Proposal for the 03 series of amendments to UN Regulation No. 129 (Enhanced Child Restraint Systems)

Submitted by the Working Party on Passive Safety*

03 series of amendments to UN Regulation No. 129 (Enhanced Child Restraint Systems)

Figures of Strapped child

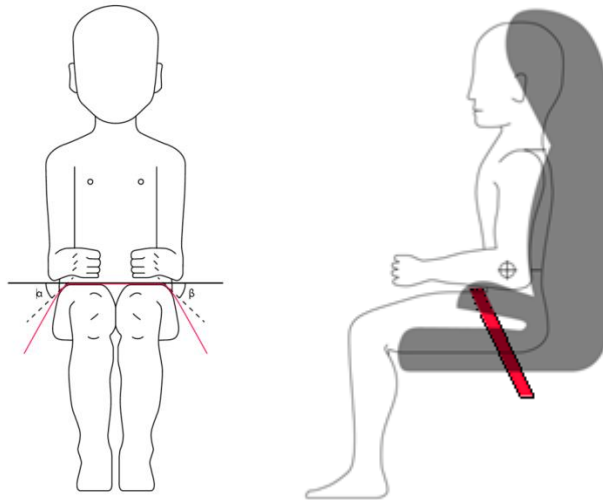
Paragraph 6.2.1.5., amend to read:

In the case of booster seats, the lap portion of the adult safety-belt shall be positively guided on both sides to ensure that the loads transmitted by the adult lap belt are transmitted through the pelvis. The positive guidance of loads over the pelvis shall be realised from the moment that the child is installed; the lap belt shall pass over the top of the thigh, just touching the fold with the pelvis. The angles α and β between the tangent line in which the belt touches the thighs and the horizontal shall be greater than 10° .

The shoulder portion of the adult safety belt shall be positively guided to ensure that the child torso and neck do not escape."

Figure 2
Arrangement for testing a rearward-facing device, not supported by the dashboard

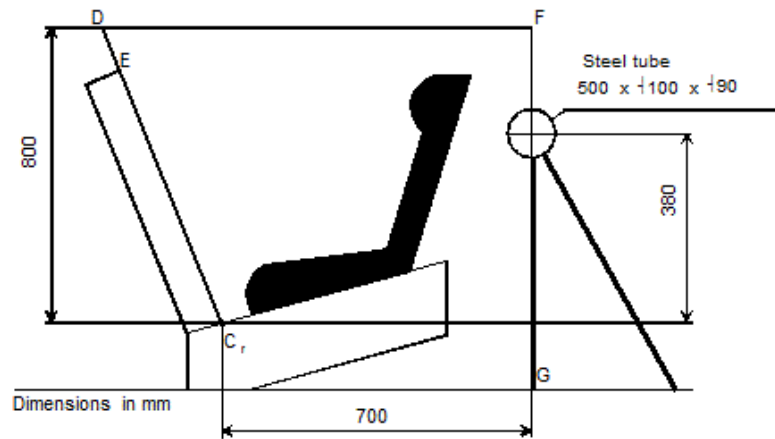
Paragraph 6.6.4.4.1.2.1., amend to read:

"6.6.4.4.1.2.1. Head excursion: no part of the head of the dummy shall pass beyond the planes FD, FG and DE, as shown in figure 2 below. This shall be judged up to 300 ms or the moment that the dummy has come to a definitive standstill whatever occurs first.

Except when testing using Q6 or Q3 dummy where the value in relation to the FD plane is 840 mm.

Where a test is conducted with paragraphs 6.6.4.1.6.1.1. or paragraph 6.6.4.1.6.1.2. or paragraph 6.6.4.1.8.2. above, only the second test results without 100 mm diameter bar will be considered.

Figure 4

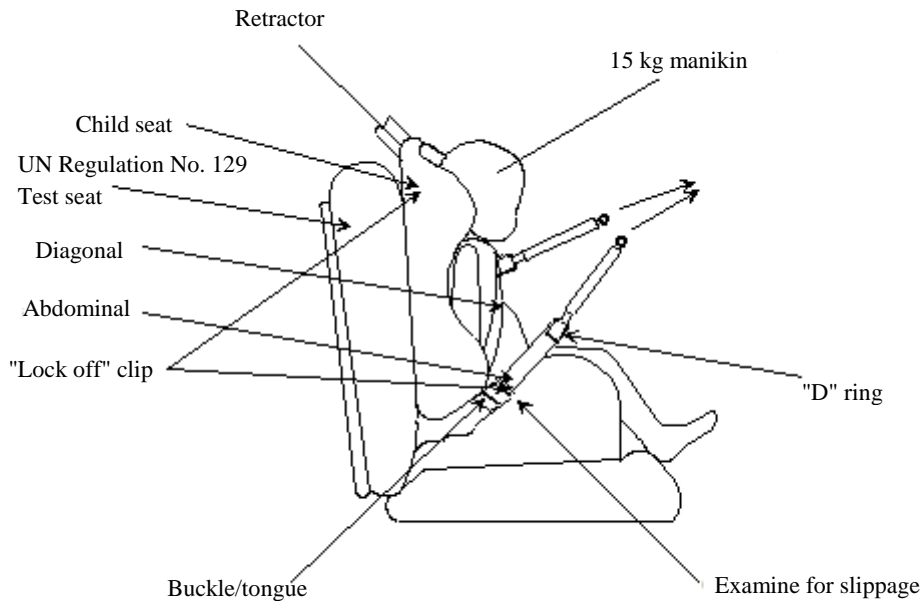
Insert new paragraphs 7.2.9. to 7.2.9.2., to read:

7.2.9.1. Class A devices

The Enhanced Child Restraint System and the largest manikin for which the Enhanced Child Restraint System is intended shall be set up as shown in Figure 4 below. The webbing used shall be as specified in Annex 23 to this Regulation. The lock-off shall be fully applied and a mark made on the belt where the belt enters the lock-off. The force gauges shall be attached to the belt via a D ring, and a force equal to twice (± 5 per cent) the mass of the heaviest dummy for the size range shall be applied for at least one second. The lower position shall be used for lock-offs in position A and the upper position for lock-offs in position B. The force shall be applied for a further nine times. A further mark shall be made on the belt where it enters the lock-off and the distance between the two marks shall be measured. During this test, the retractor shall be unlocked.

Figure 1
Procedure type 1

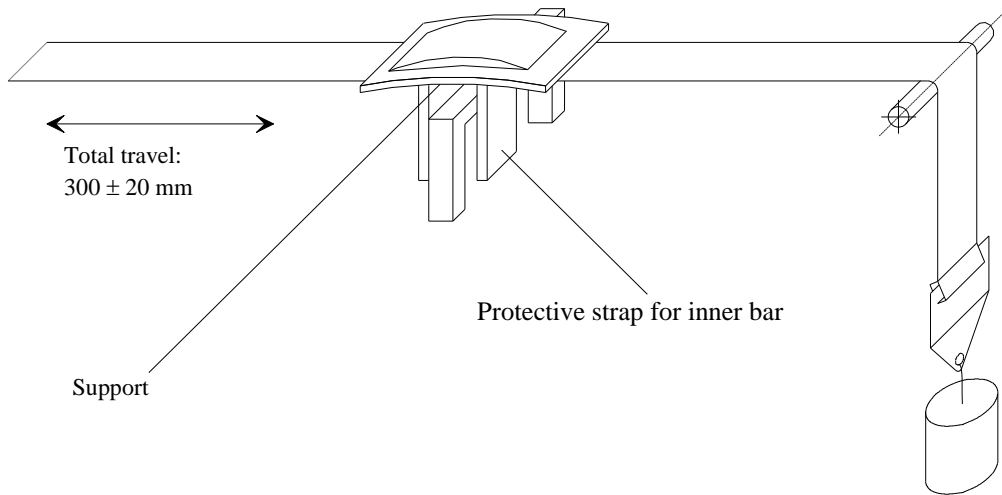
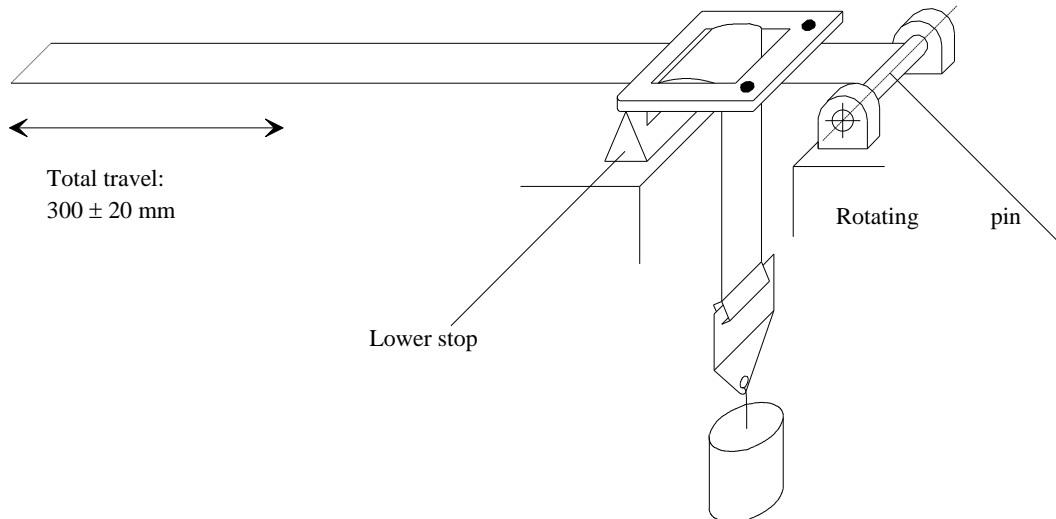
Annex 5, Figures 1 and 2, amend to read:

$F = 10 \pm 0.1 \text{ N}$, can be increased up to maximum $F = 60 \pm 0.5 \text{ N}$ (see table 8, paragraph 7.2.5.2.6.2.)

Figure 2
Procedure type 2
 Following two examples of test set up

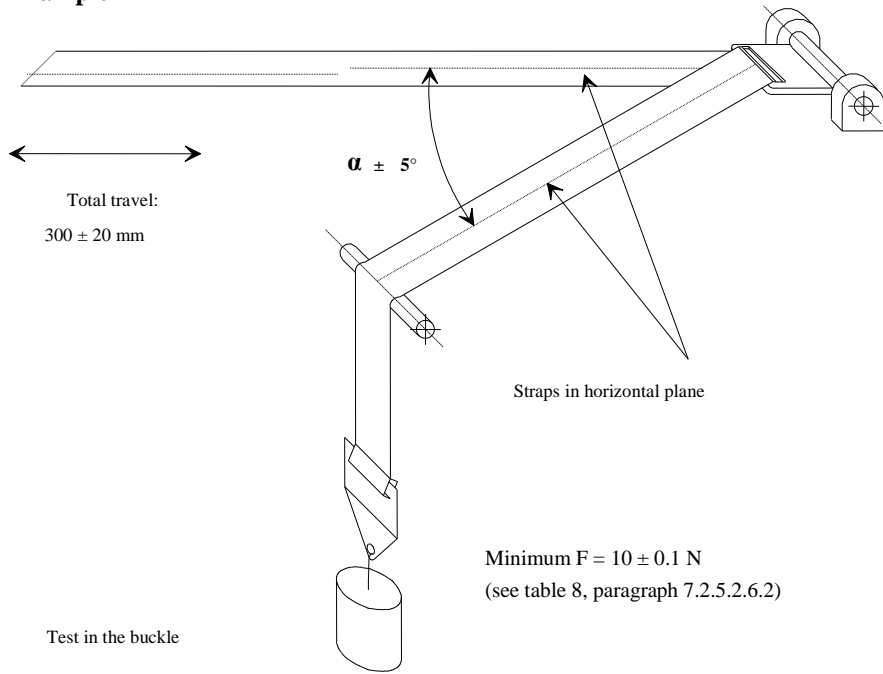
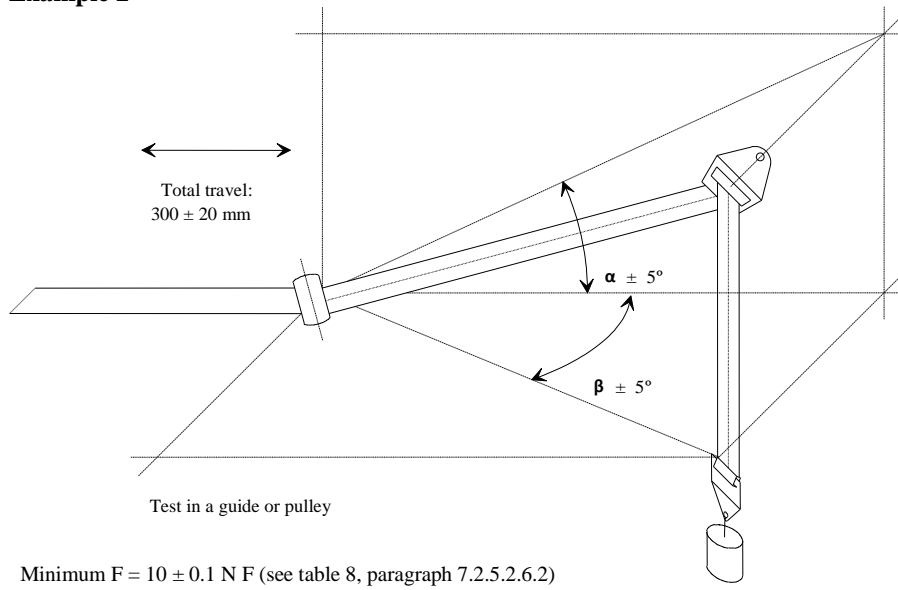
Where α and β reproduce the angles as in the real installation (in three dimensions)
 ..."

"Figure 5

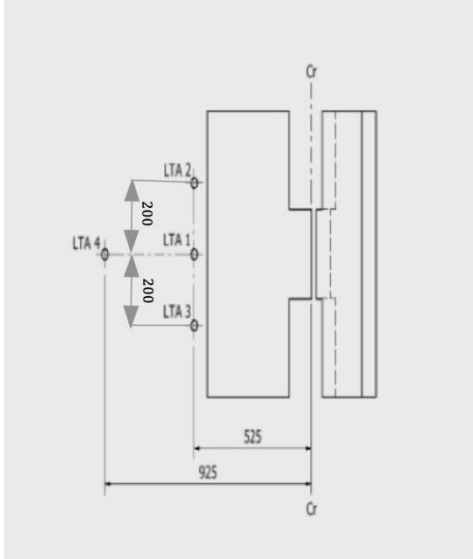
Appendix 2, insert new figure 5:

Lower strap anchorages (LSA 1, LSA 2, LSA 3 and LSA 4)

Figure 3

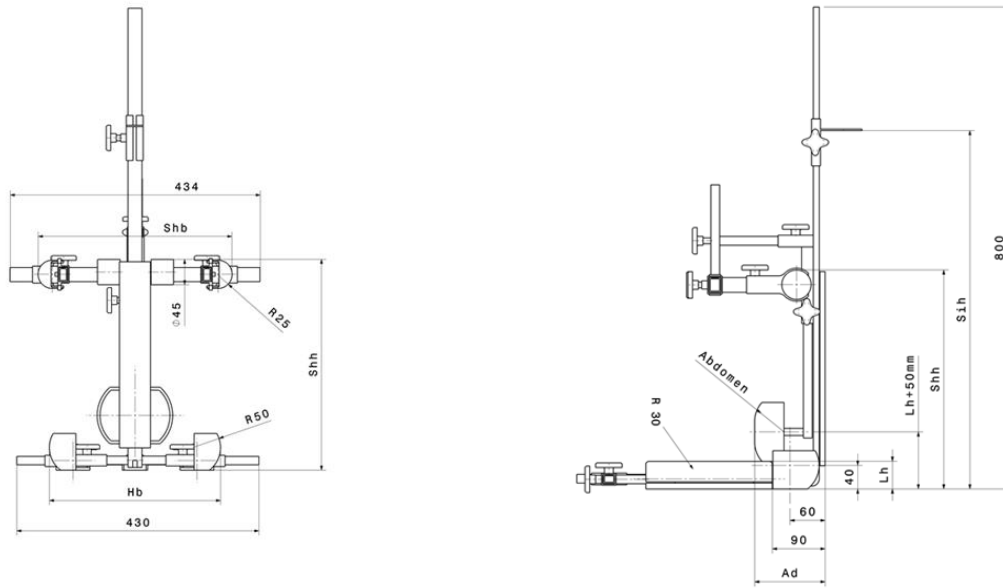
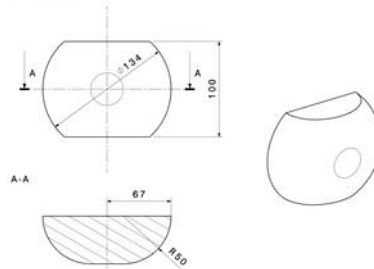
Annex 18, amend to read:

Side and Front View of the measuring device for measurements applicable to Enhanced Child Restraint Systems that feature an impact shield
